**GFA AD 496**

AMT 200 Super Ximango.

Position of Fuel Pump Placard.

S. B. N° 200-28-057

Figure #1

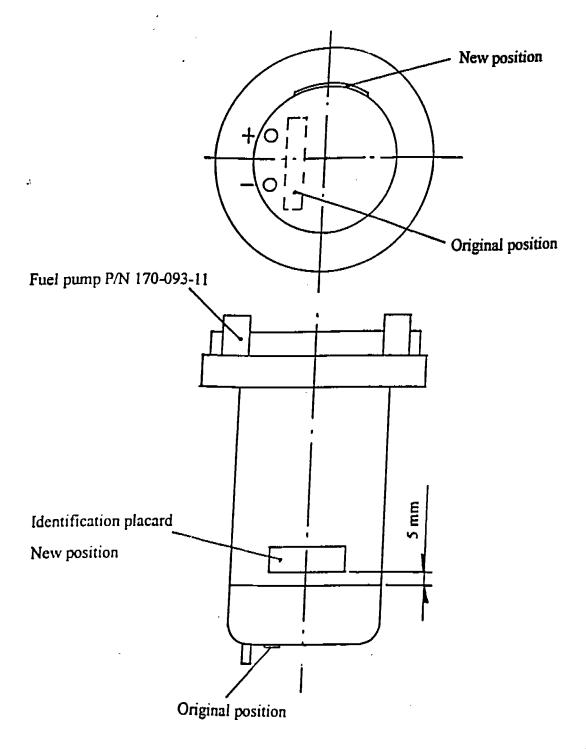
- 2.2 Remove the identification placard of the fuel pump gaining access through the cockpit floor behind the central console. Use a screw driver with long shaft and thin blade to loosen the placard. The identification placard is located at the front surface between the positive and negative connection terminals.

- 2.3 Sand lightly the glued surface of the placard to remove old glue. Clean the placard from dirt and dust.
- 2 Bend lightly the placard to match it with the curvature of the fuel pump housing (see figure #1 in the annex).

- 2.5 Prepare epoxy resin (24 hours epoxy glue CIBA GEIGY or similar) and glue the identification placard on the top of the pump housing 5mm below the edge of the metal part of the housing (figure #1 in annex).
